RE: **Lot 15 Block 2 SAD 228**
Volcano Cliffs Subdivision
6508 Camino Del Oeste NW
Grading and Drainage Plan
Engineers Stamp Date 11/28/17 (D10D003G15)
Pad Certification Date: 12/4/17
CO Certification Dated: 6/7/18

Based upon the information provided in your submittal received 6/7/18, this plan cannot be approved for Certificate of Occupancy until the following comments are addressed.

ENGINEER'S SEAL	6508 CAMINO DEL OESTE	DRAWN BY WCMJ
	GRADING AND DRAINAGE PLAN	DATE 11-23-17
		21811-LAYOUT-10-16-17
11/28/17 11/26/17		SHEET # —
DAVID SOULE P.E. #14522	Rio Grande Engineering 1606 CENTRAL AVENUE SE ALBUQUERQUE, NM 87106 (505) 872-0989	JOB # 21808

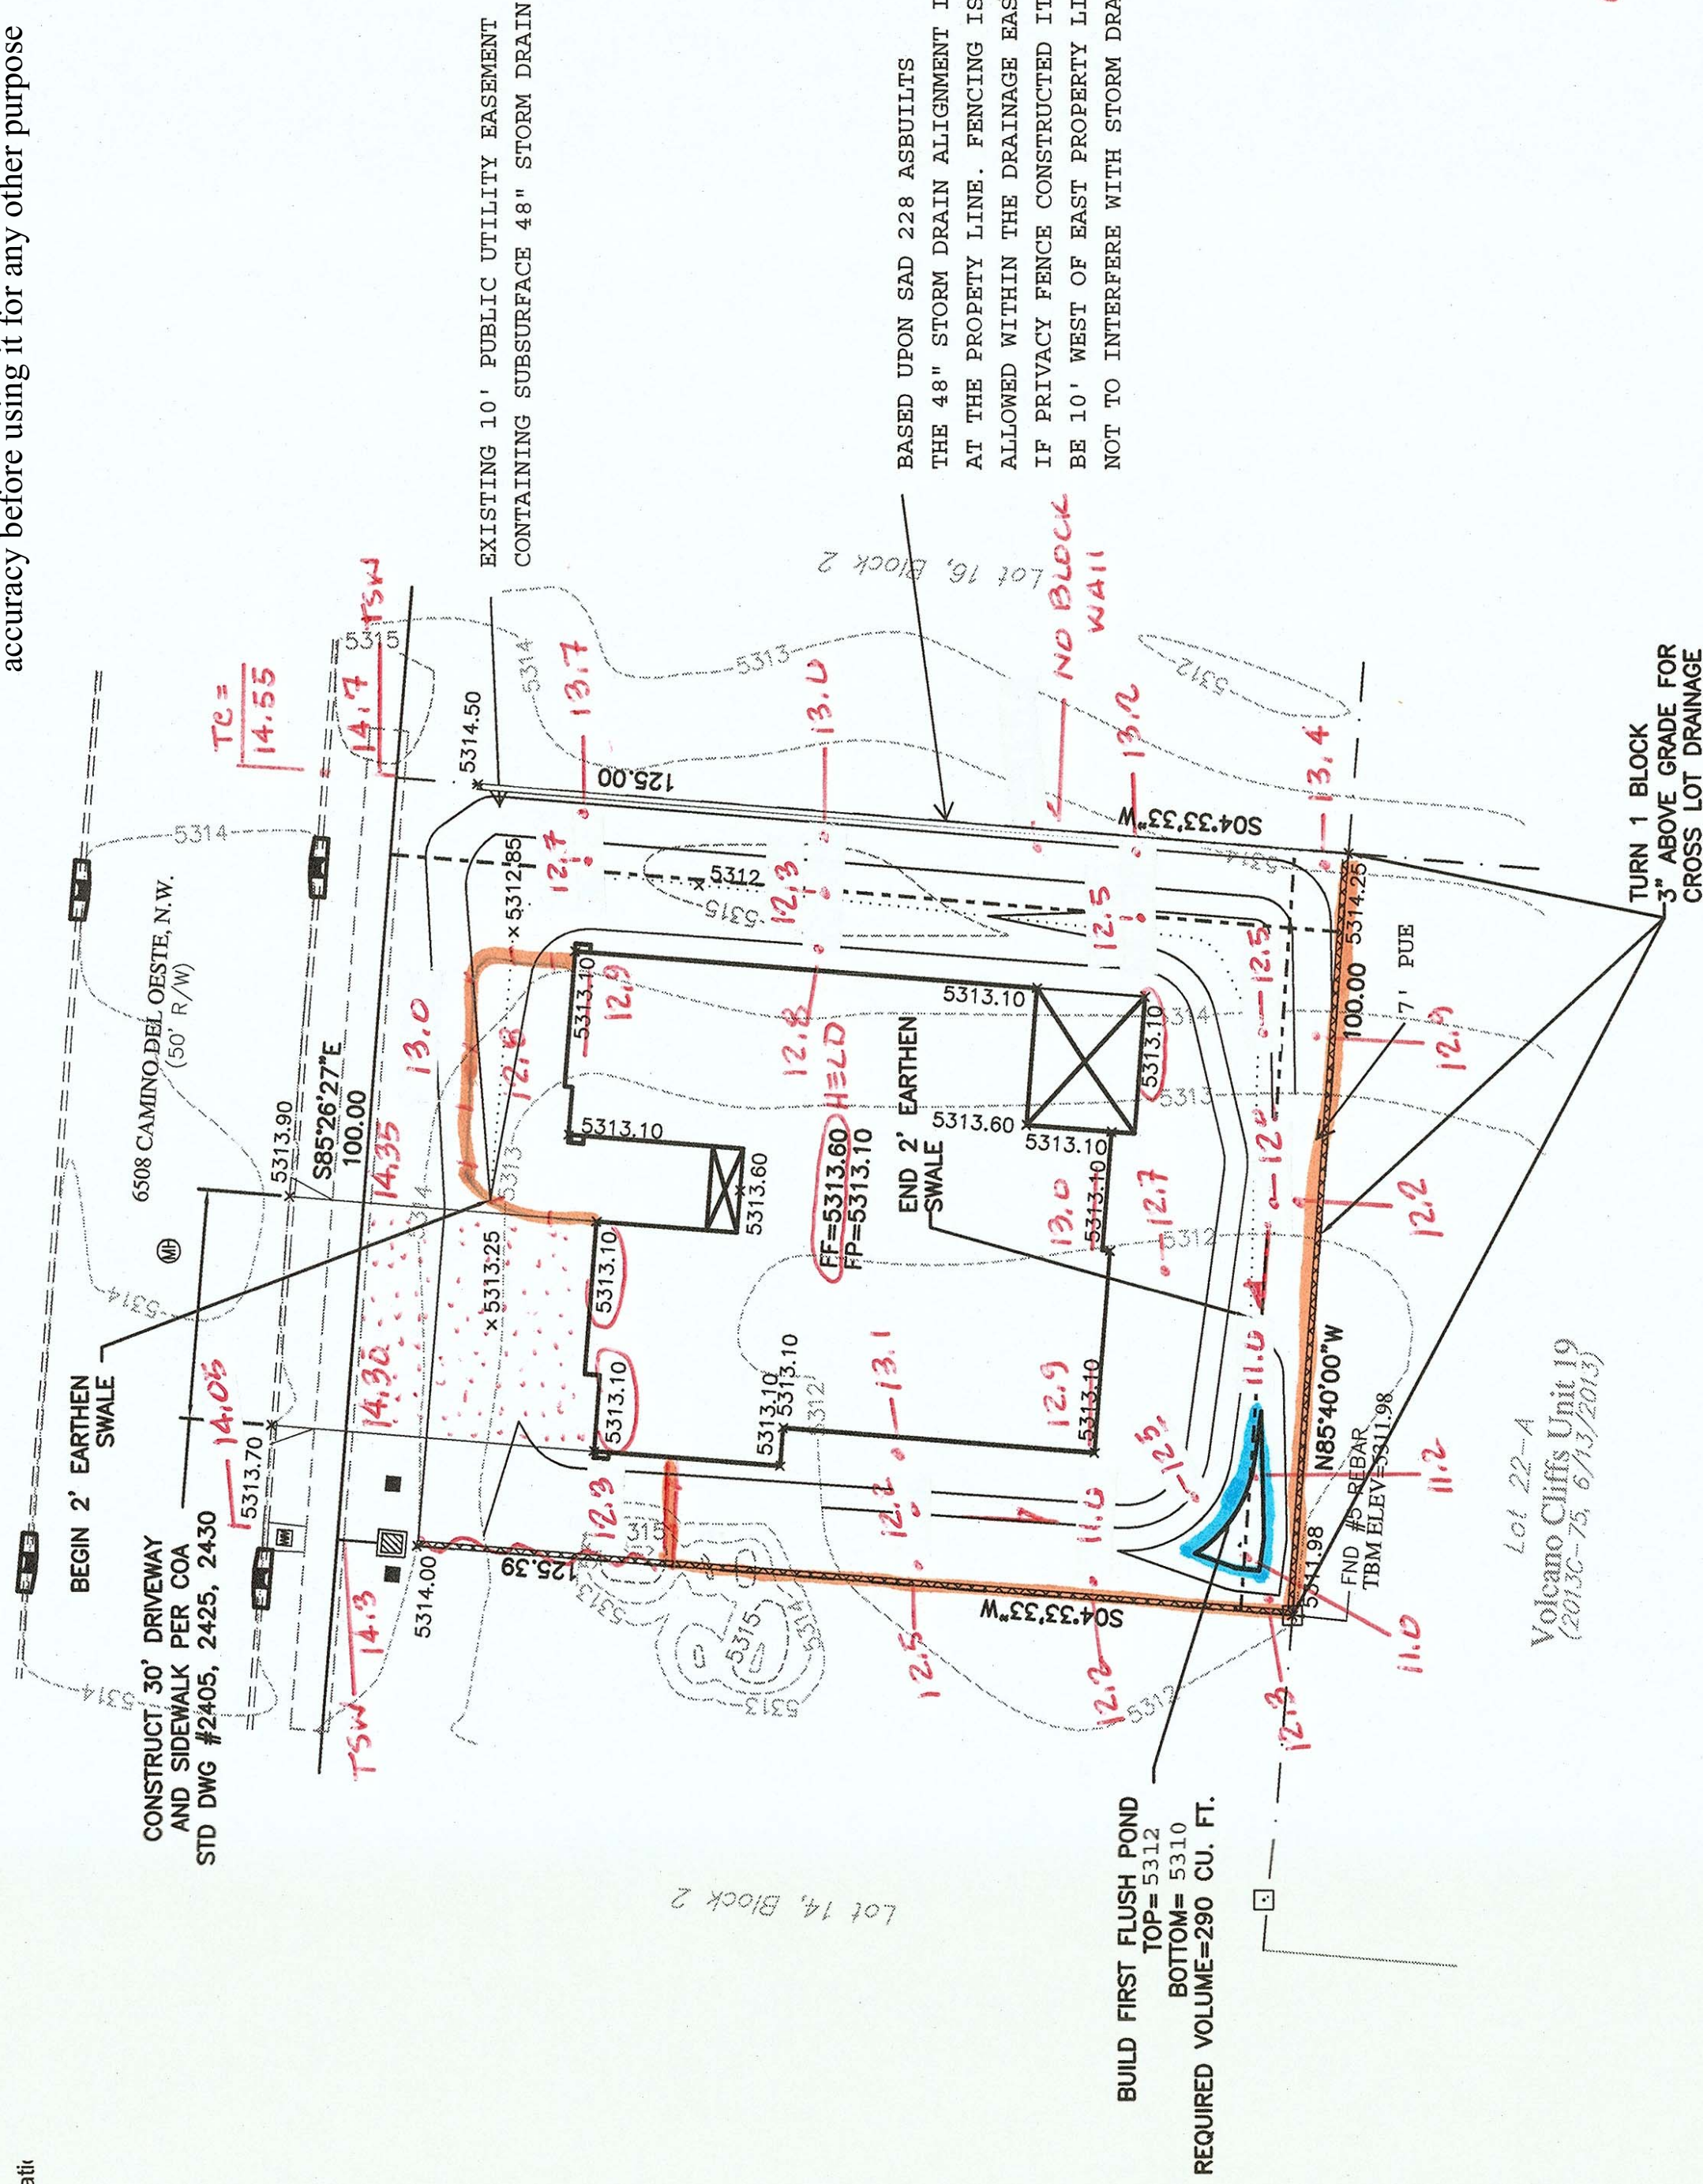
- Remove the concrete slabs in the public right of way.
- Remove all concrete and debris in and around the site.
- Remove the gravel in the street.
- Provide turn blocks as noted on the approved plan.
- Provide opening in front yard garden wall where swale is located.
